Technical Service Bulletin

Transaction No.: **2079136/3**

91 Driver assist systems: failure of various driver assist systems, DTC "B201000: No basic setting" in DA 810B

Release date: Jun 11, 2026

Figure 1. Incorrect cable routing (left in image) and correct cable routing (right in image) of bumper wiring harness

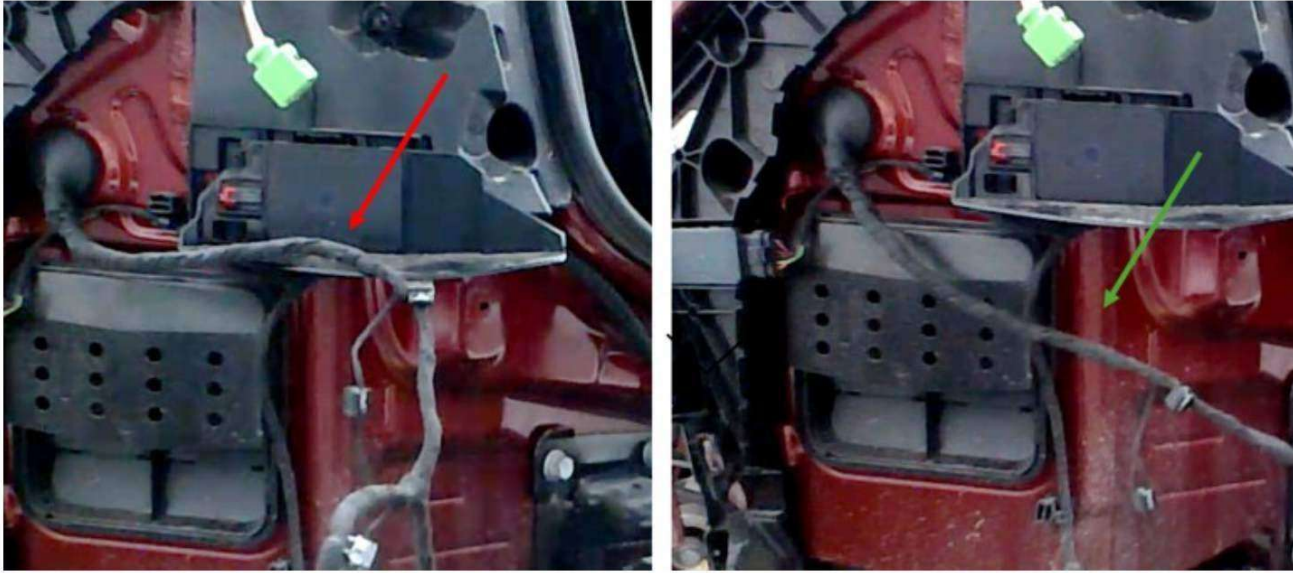
Potential incorrect cable routing of bumper wiring harness – causes harness to obstruct field of view of the sensor of lane change assist control unit -J770-. Please refer to the following images and the video provided in the TSB.

Figure 1 (left) shows incorrect cable routing of bumper wiring harness in field of view of sensor of lane change assist control unit -J770-

Figure 1 (right) shows the correct routing of the bumper wiring harness below the field of view of sensor.

Incorrect cable routing in the field of view of the sensor may be the cause of the event memory entry **"B201000: No basic setting (symptom number 1301)"**.

Install the rear bumper cover and make sure that the bumper wiring harness is routed below lane change assist control unit 2 J770 (see Figure 1, right).

Figure 3. Left – previous cable routing. Right – new cable routing with cable tie with clamping base 3D0.971.838.L

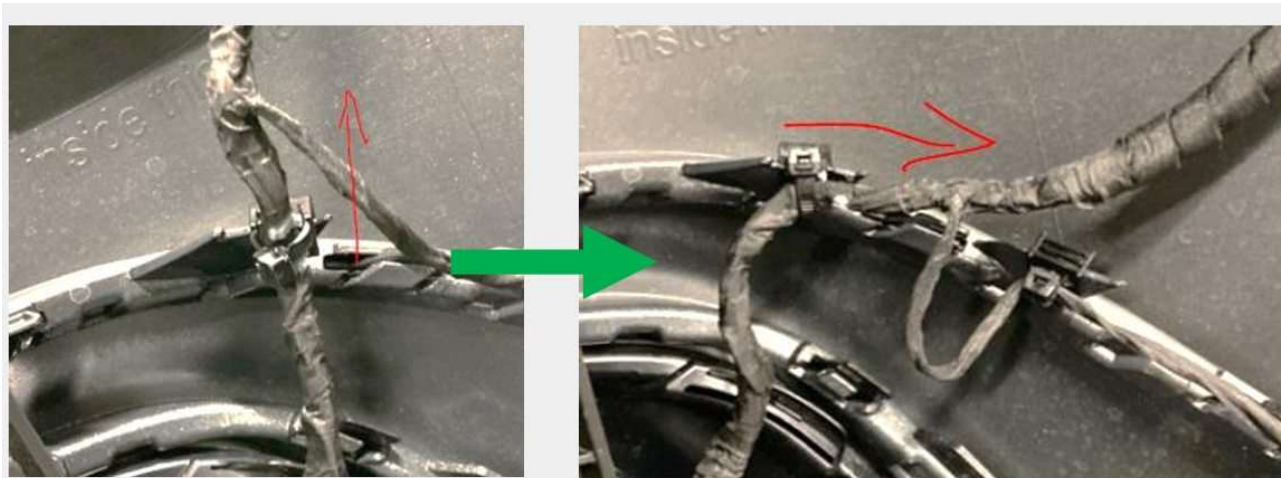
Remove the rear bumper cover. Remove the wrong cable tie with clamping base at the position shown (see Figure 2) and affix cable tie with clamping base 3D0.971.838.L in its place.

The new cable tie enables the cable to be rotated 90° and makes it easier to route the cable (see Figure 3).
